Regulation No. 100**Uniform provisions concerning the approval of vehicles with regard to specific requirements for the electric power train****Contents**

Figure 1
Jointed test finger

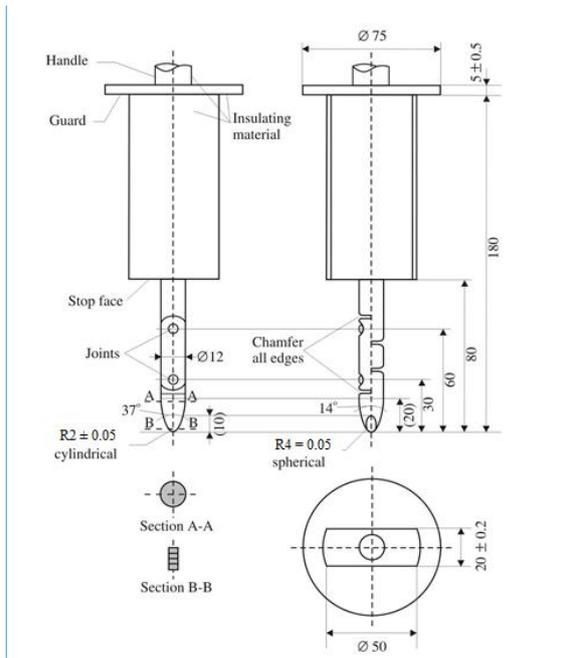
Kommentiert [MI 21]:
 Toyota:
 Error in the dimension.
 Wrong) R4 = 0.05 spherical
 Correct) R4 ±0.05 spherical
